APPROVED MINUTES

January 20, 2022 Standards Committee Meeting

RE: Minutes from the January 20, 2022 Standards Committee Meeting

802-DMSS (existing -01 thru -23, shown markups) DYNAMIC MESSAGE SIGN STRUCTURE

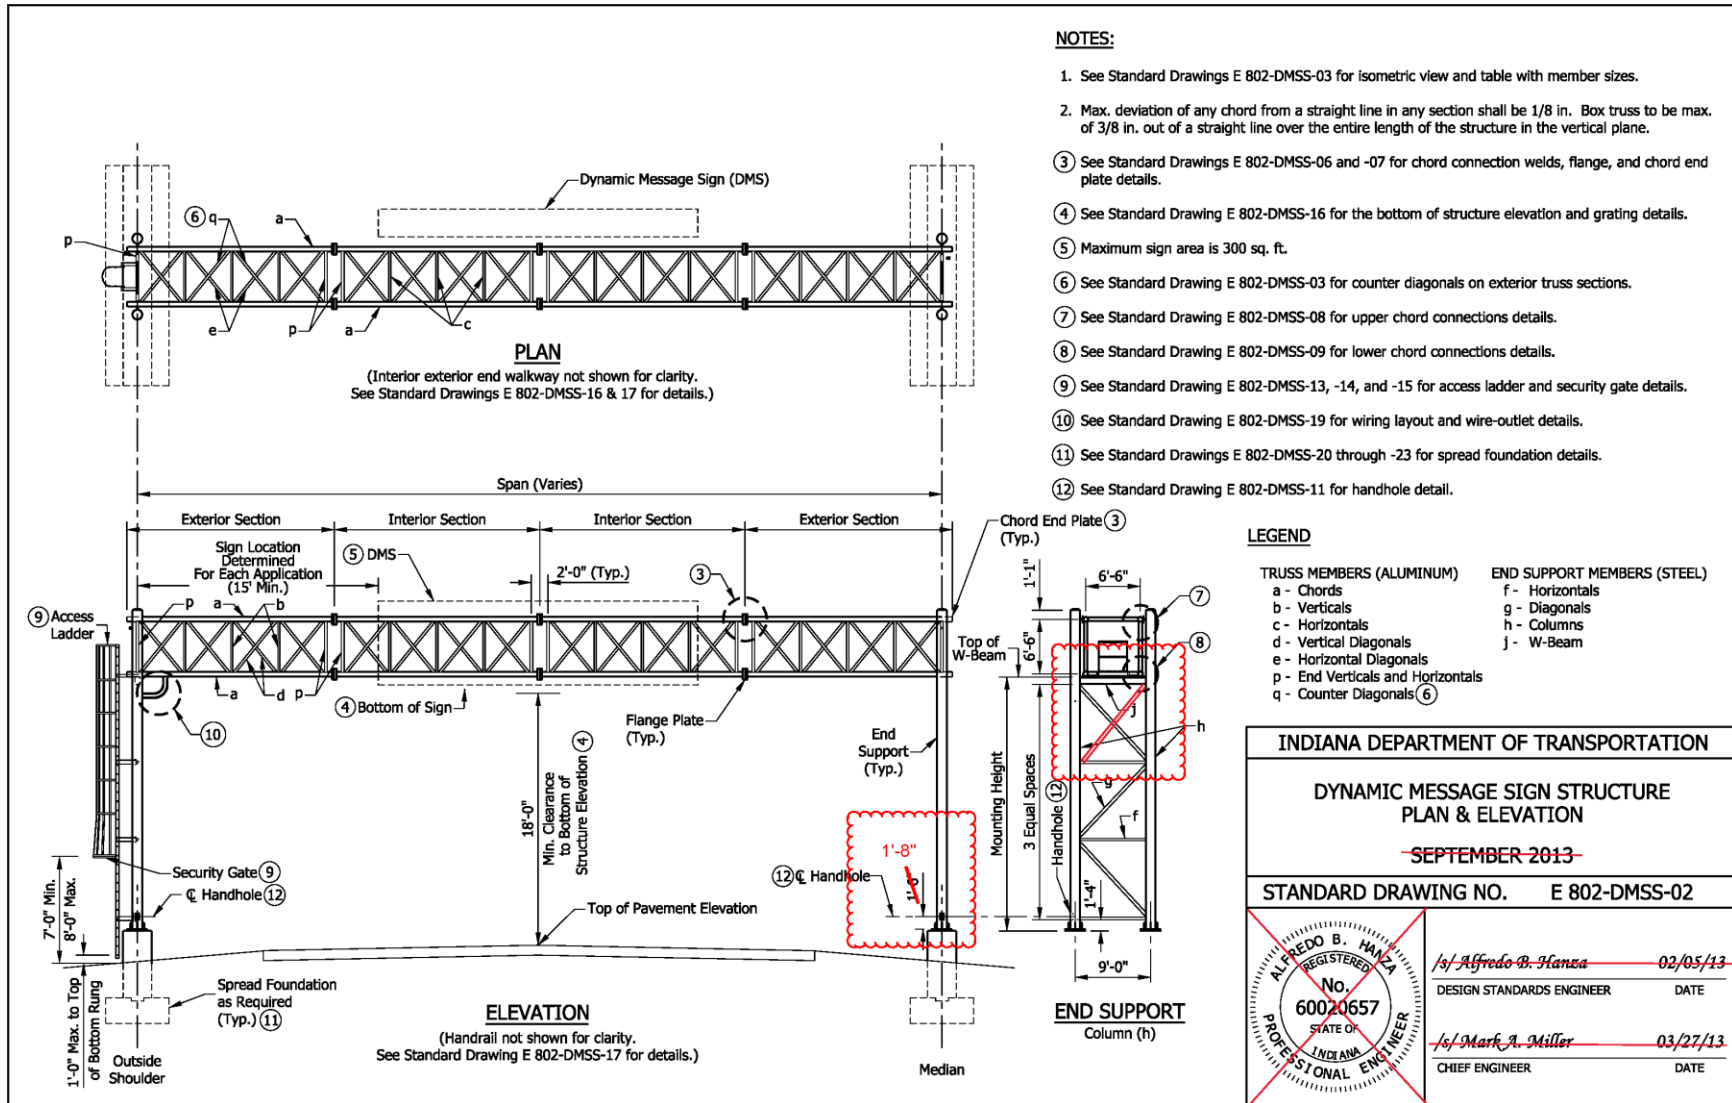
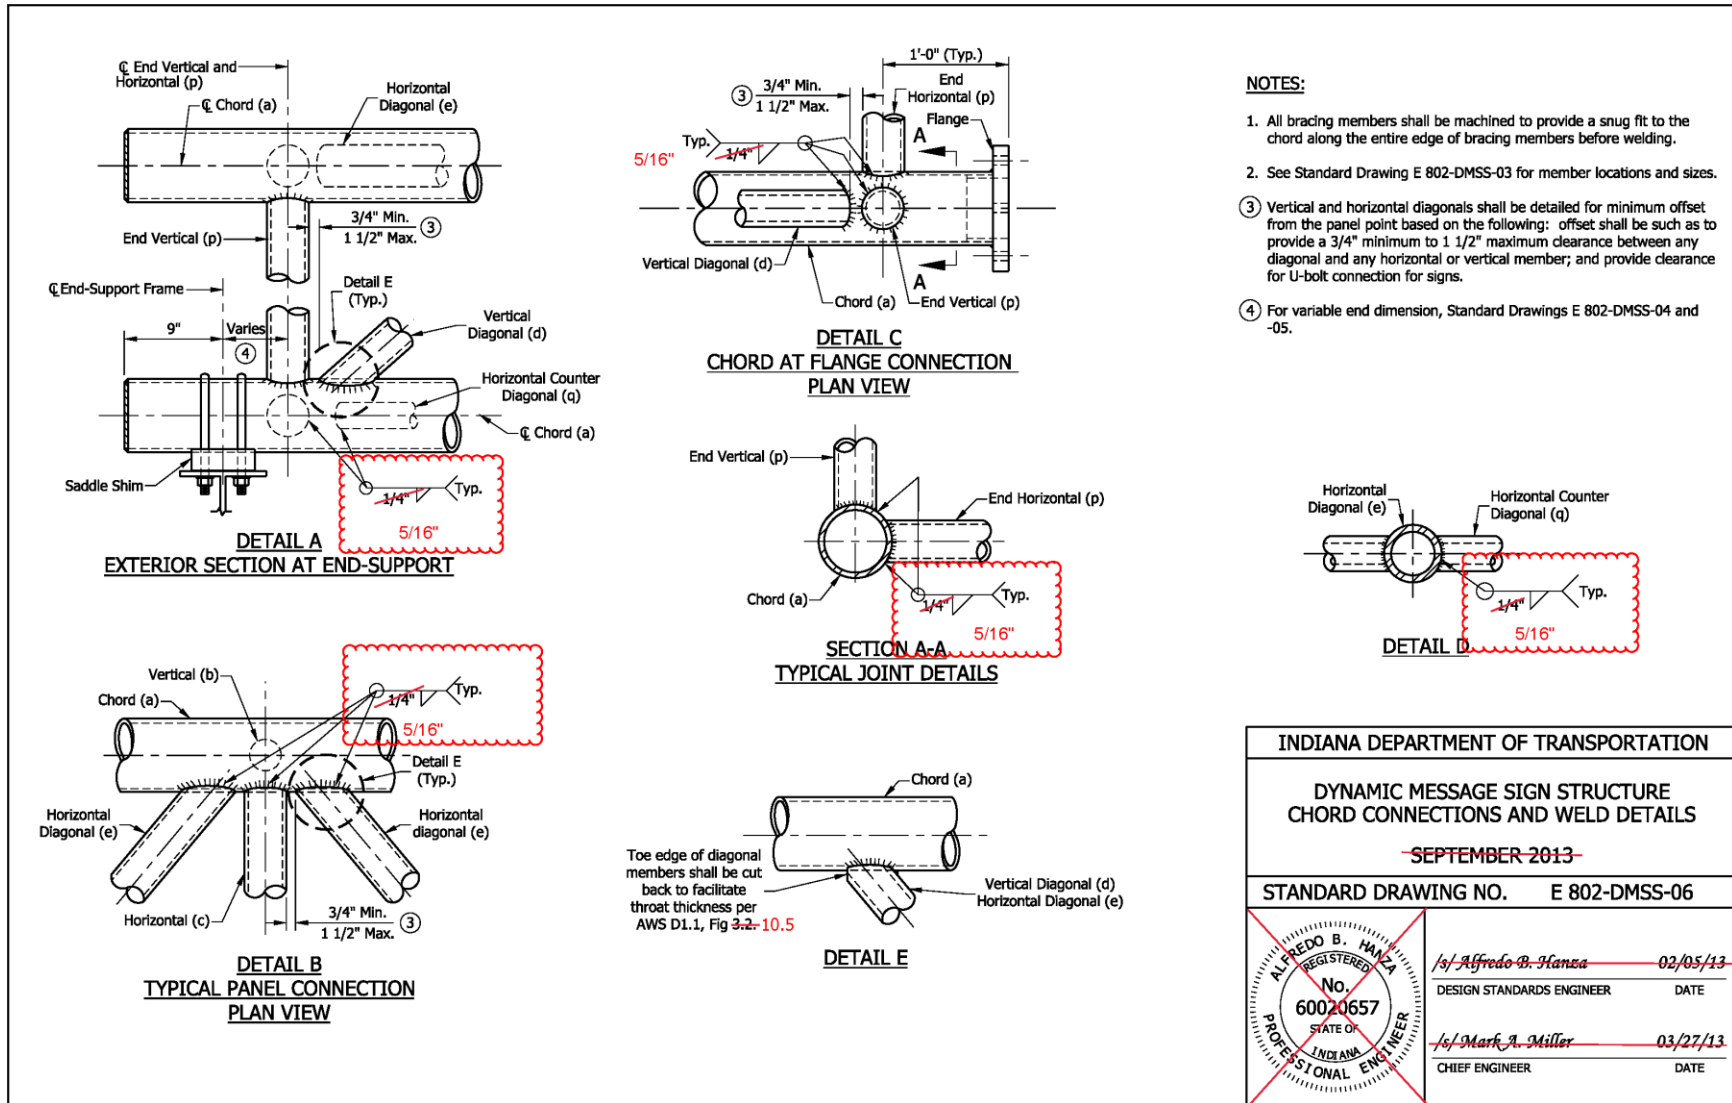
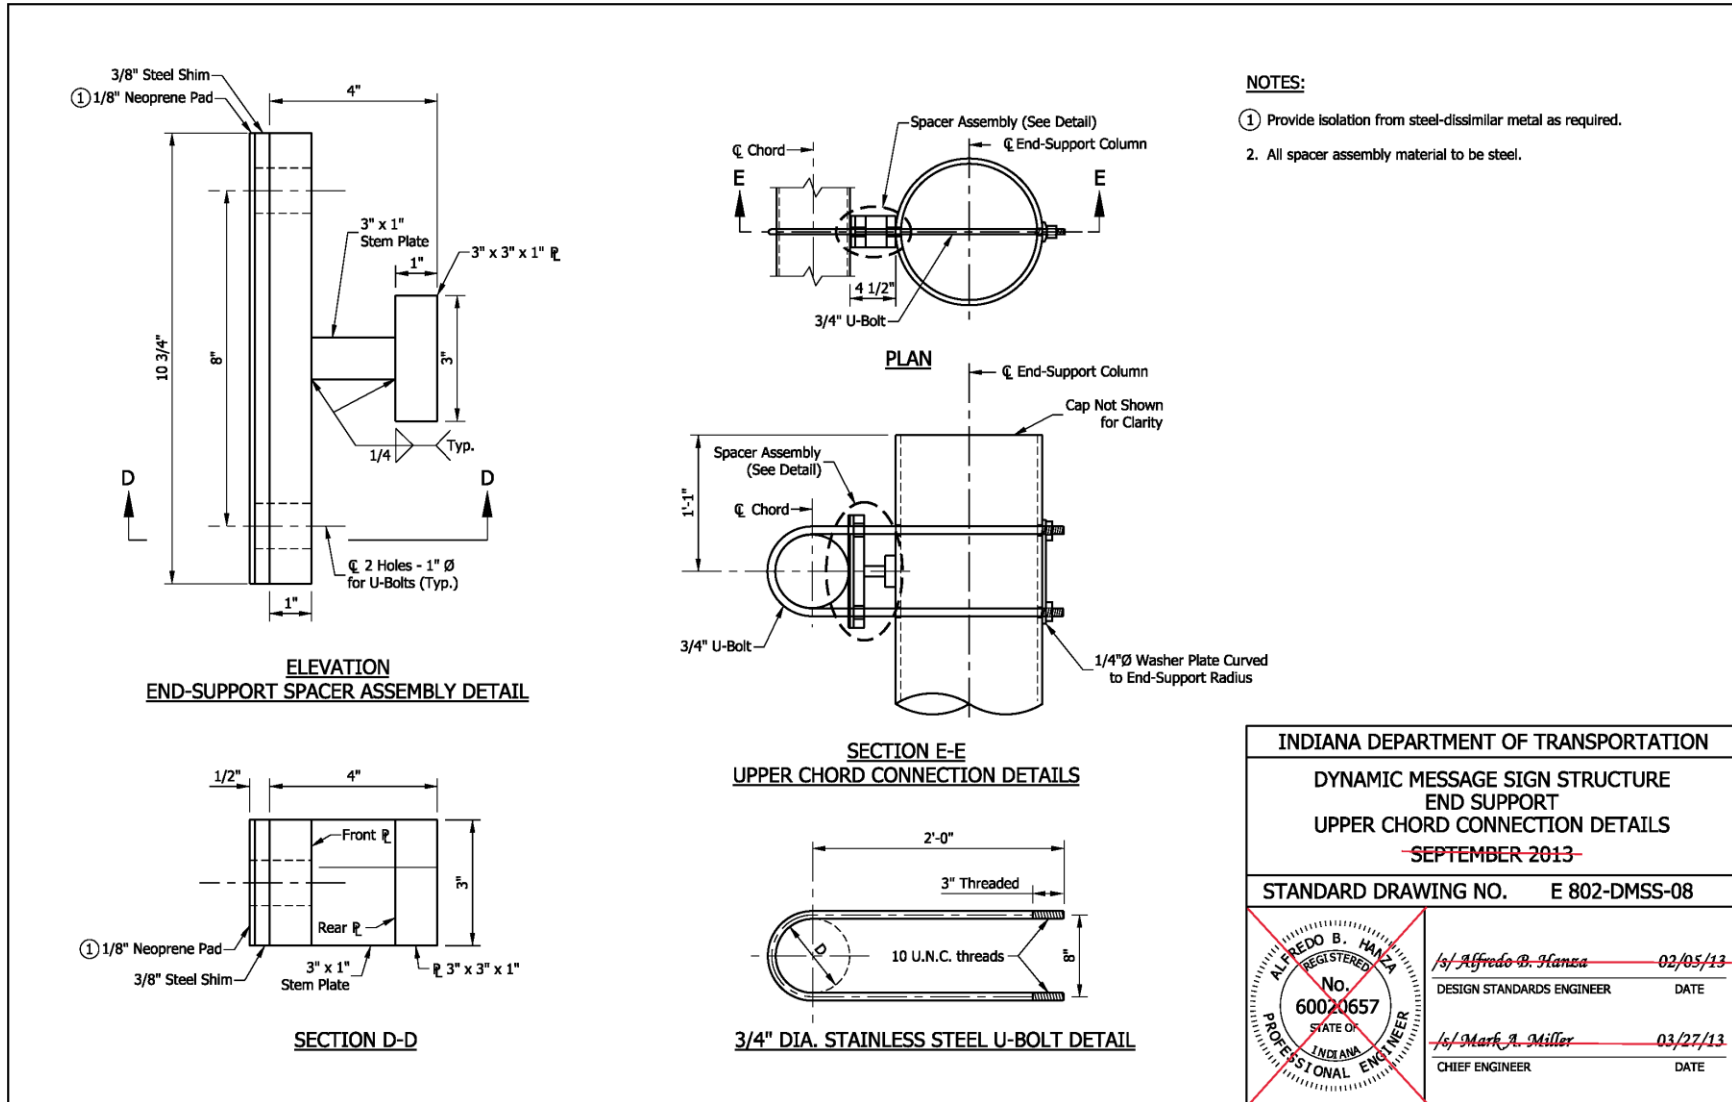
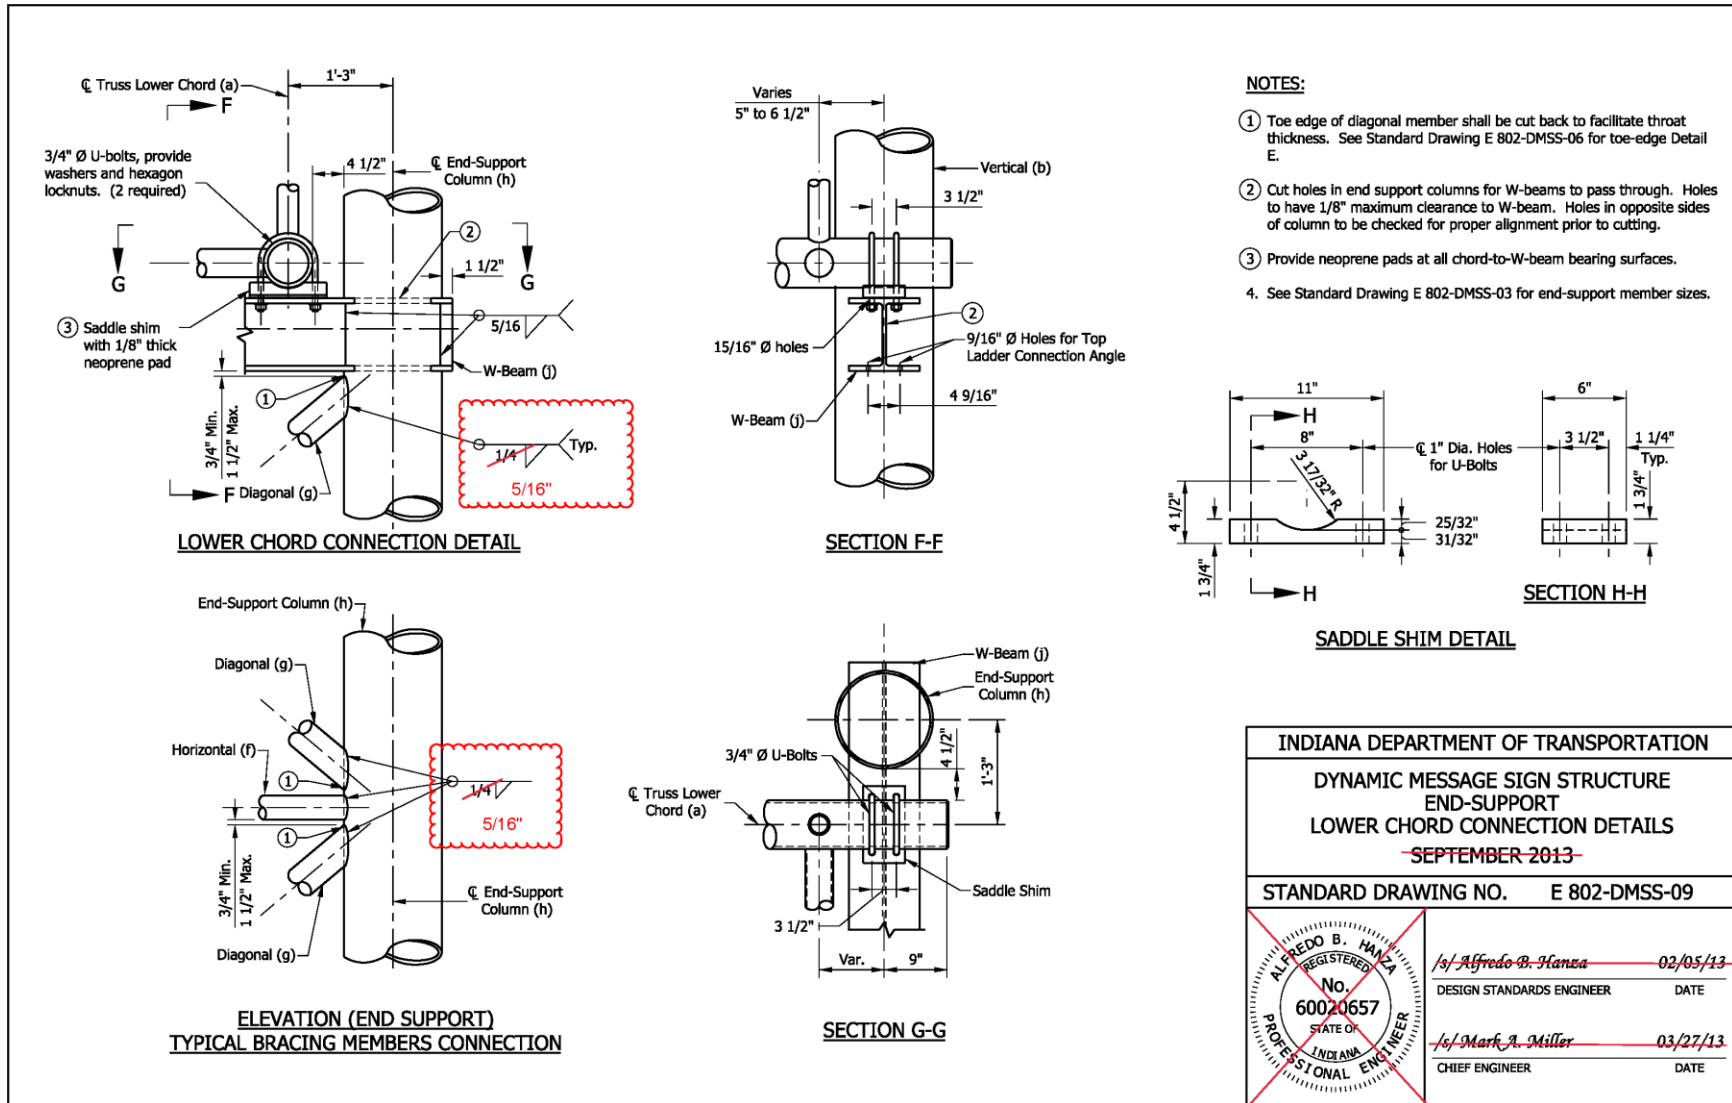
PROPOSED SOLUTION: Design the structures per latest AASHTO LRFD 2015 code, revise the standard drawings accordingly. Add detail on the proper anchor bolt hardware tightening order ("star pattern"). Add a detail for drain holes in the handrail post (DMSS series).

I.D. PLATE AND OTHER DETAILS
 ADDED TO SHEET

- ① See Standard Drawing E 802-DMSS-11 for handhole details.
2. See Standard Drawing E 802-DMSS-12 for anchor bolts and skirt details.
- ③ I.D. tag is a 1/8" stainless steel plate with the following information stamped in 1/2" black letters:
~~Manufacturer~~, ~~Drawing/Order #~~
~~Contract #~~, ~~Structure Type~~
~~Fabrication Date~~, ~~Structure Length~~
~~End Support Mounting Height~~
4. Each end support requires one I.D. tag.
